Proposed Changes to SDD11 / SDD22 Return Loss Masks

John D'Ambrosia
Tyco Electronics

Proposed SDD11 / SDD22 Model

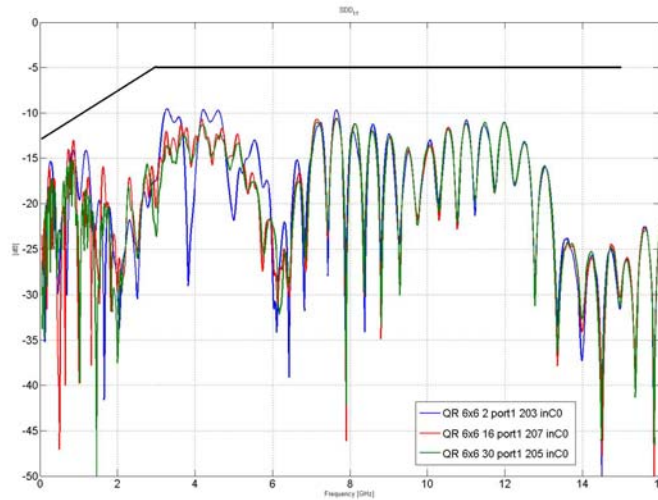
- For 0 to 3 GHz
 - $SDD_{xy} = 2.7e-9 * \text{frequency} - 13$ (dBm)
- For 3 GHz to 15 GHz
 - $SDD_{xy} = -5$ (dBm)

Proposal to Signaling Ad Hoc

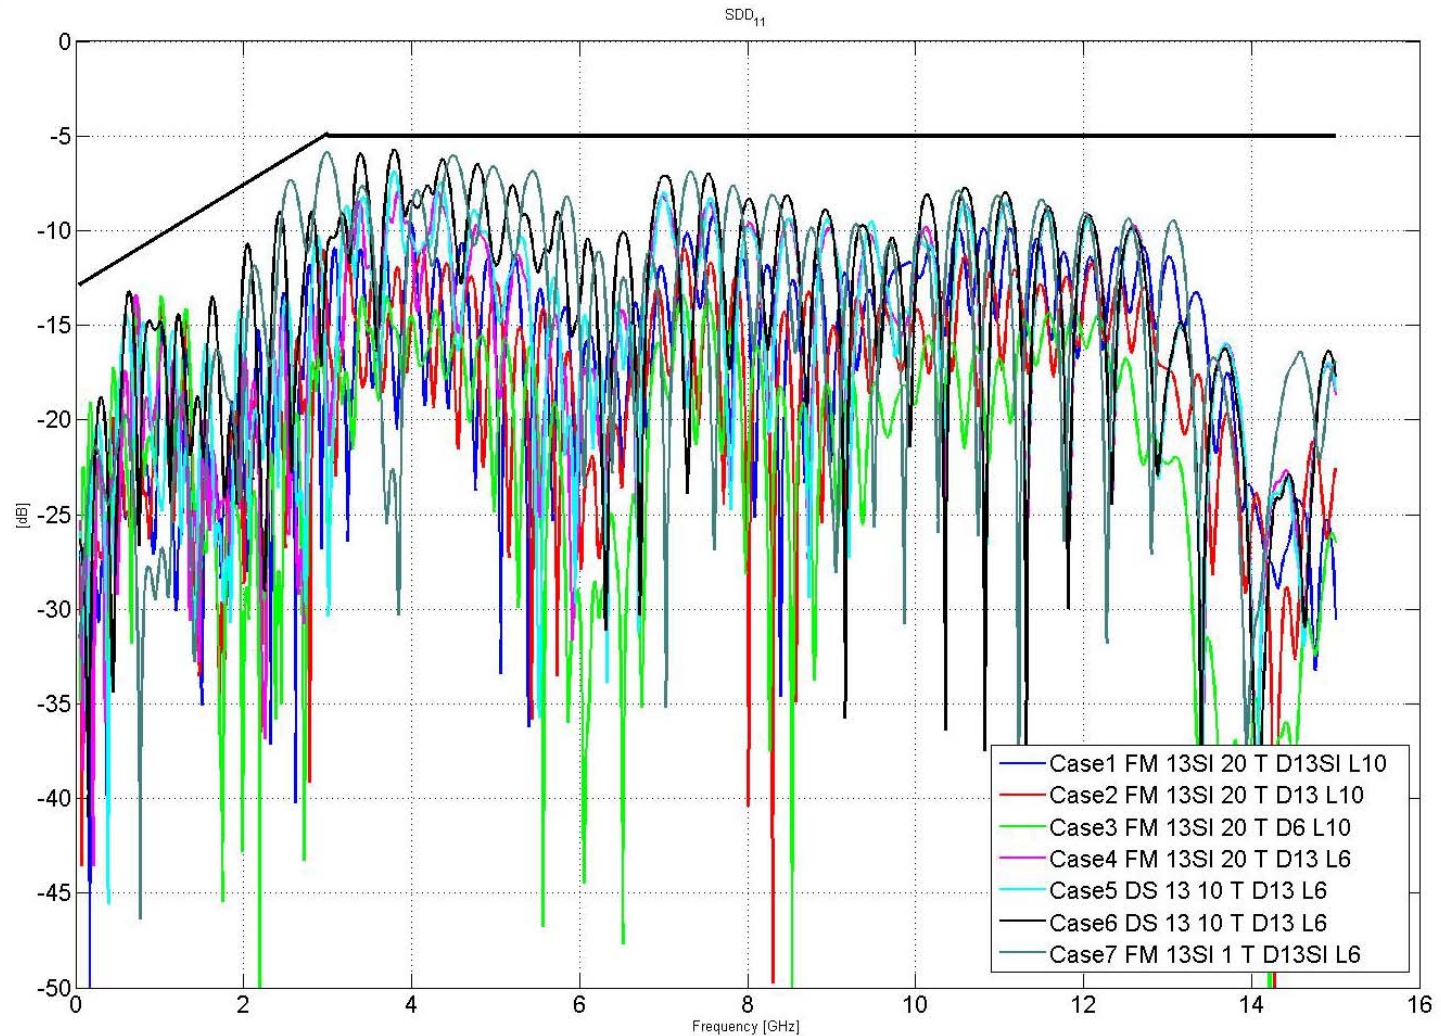
- Return loss is a system issue
- Daughtercard layer connection primary source
 - Limited ability to counterbore
 - Only 0.092" daughtercards tested, switch card could be 0.150"
- Proposed mask passes all cases
